SHINE MEDICAL TECHNOLOGIES, LLC

**MEETING SLIDES FOR THE MARCH 4 AND 5, 2020 PUBLIC MEETING
BETWEEN SHINE MEDICAL TECHNOLOGIES, LLC AND THE NRC**

**TRITIUM PURIFICATION SYSTEM (TPS) DESIGN CHANGE
PUBLIC VERSION**

Deuterium Supply to NDAS

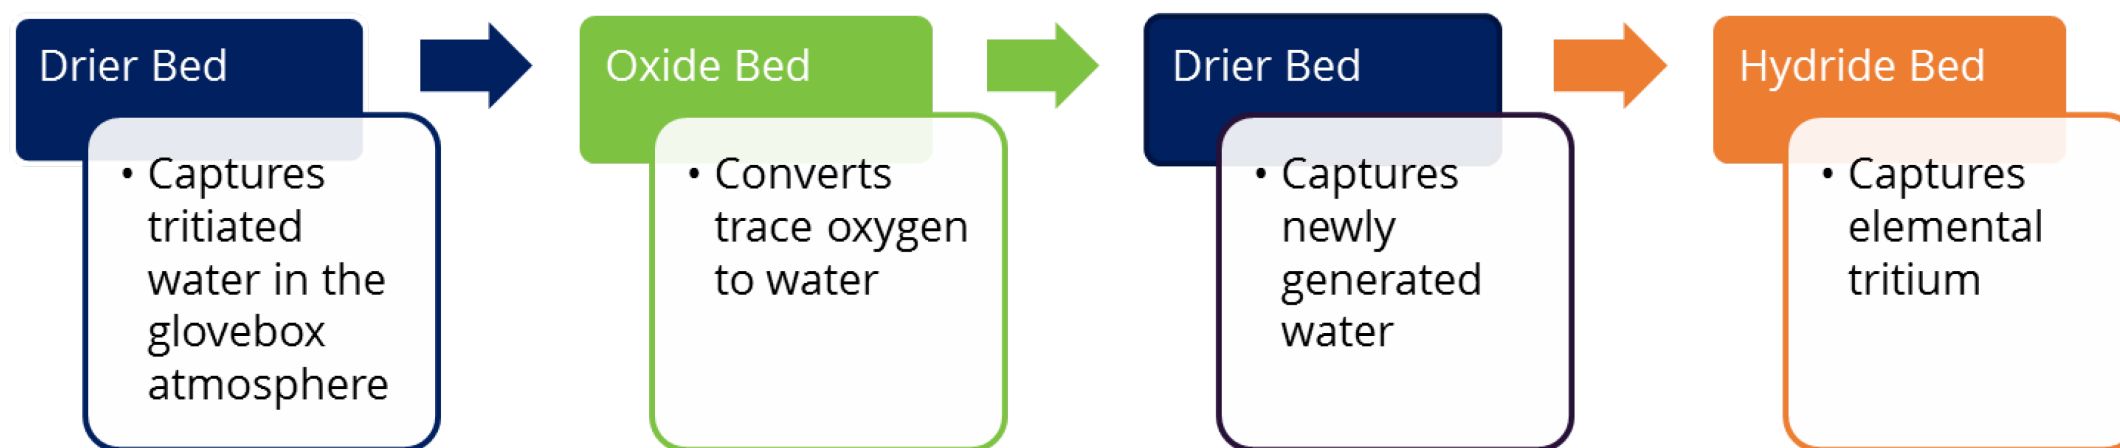
- Deuterium supply to NDAS provided through an external supply bottles instead of through the deuterium side of TCAP.
- Deuterium supplied to NDAS ion source exhausts to facility ventilation instead of recycling deuterium back to TCAP.
- Reduces load on isotope separation equipment, reducing component size and system complexity.
